Our Ref: 21080

RE: SDCC PLANNING REG. REF. SDZ22A/0007

#### RESPONSE TO FURTHER INFORMATION REQUEST

**Figure 3:** Extract from Drawing Number 5150924/HTR/10/SK/0004 'Existing and New Temporary P&R', prepared by Atkins Consulting Engineers

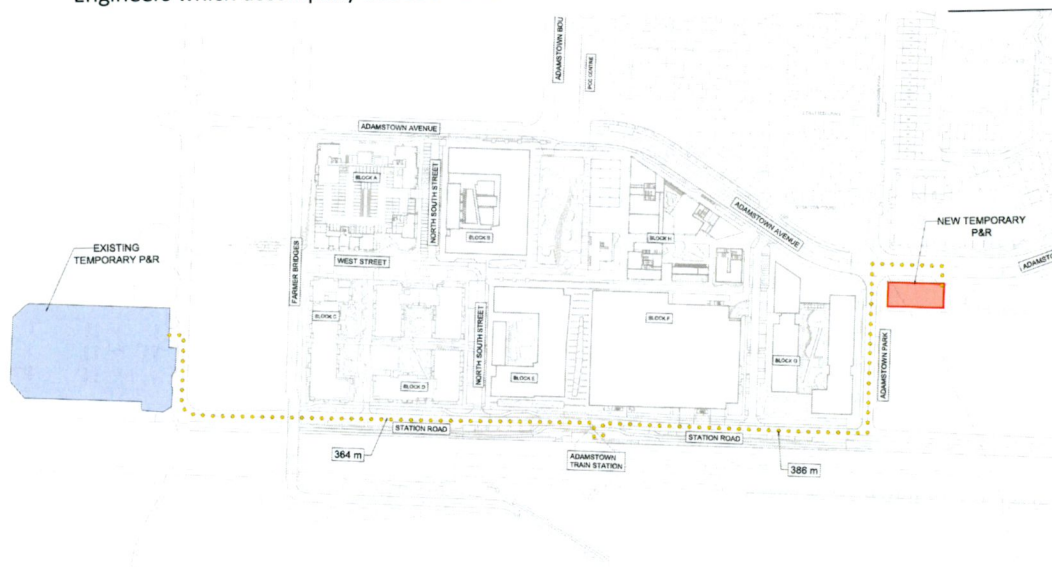
*The NTA has requested that the temporary park and ride on the subject site be retained until such a time as a permanent park and ride is available. The applicant is requested to provide a response to the concerns raised by the NTA in this regard.*

It is not proposed to retain the existing temporary park and ride facility on site. Anecdotal evidence suggests that this temporary park and ride is in use predominantly by construction workers, with limited cars parked in this facility on a daily basis. It is proposed to use the existing car park located in the Adamstown Square Development Area as a replacement temporary park and ride car park. This contains 26no car parking spaces, including 2 spaces for disabled drivers. We can confirm that the lands on which this car park sits are in the control of the Applicant.

The proposed replacement temporary park and ride facility is located a 4 minute walk from the Adamstown Train Station, approximately 386m away. The existing park and ride facility is located a 4 minute walk from the Adamstown Train Station, approximately 364m away.

Figure 3 below shows the approximate relative proximity of the existing temporary park and ride versus the location of the proposed temporary park and ride facility. We additionally refer the Planning Authority to the enclosed Park and Ride Drawings, prepared by Atkins Consulting Engineers which accompany this submission.
